Re: **Approval of Abatement Plans, (Violation #N93-39-5-3 # of 3), Skyline Mine, Utah Fuel Company, ACT/007/005-93M, Folder #2, Carbon County, Utah**

Re: Approval of Abatement Plans, Alternate Sediment Control

The following is our response to the Division's May 21, 1994, deficiency letter:

TYPICAL CONVEYOR BENCH
WITH CROSS SLOPE

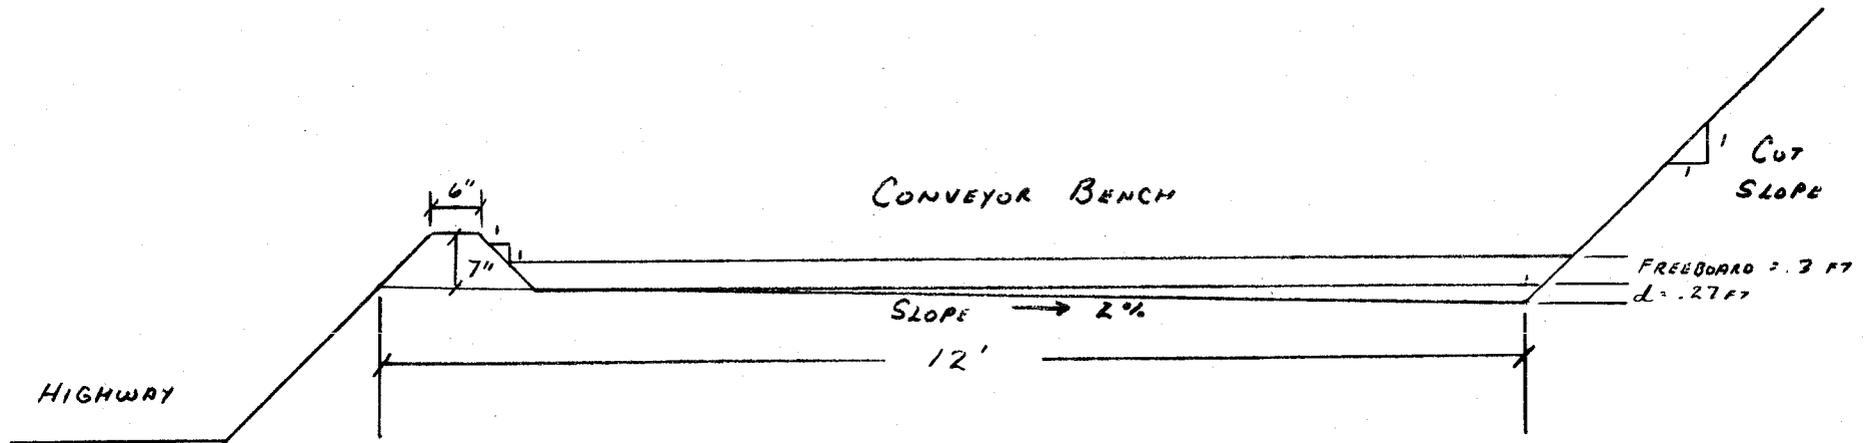
Deficiency No. 2. Runoff calculations must be provided for the area to be treated by Alternate Sediment Control Measures in order to demonstrate that the proposed design is adequate. (One calculation showing the worst case scenario may suffice.)

Response: We have included engineering calculations for worse-case scenario. We have also included a design showing a typical diversion berm and insloping when necessary.
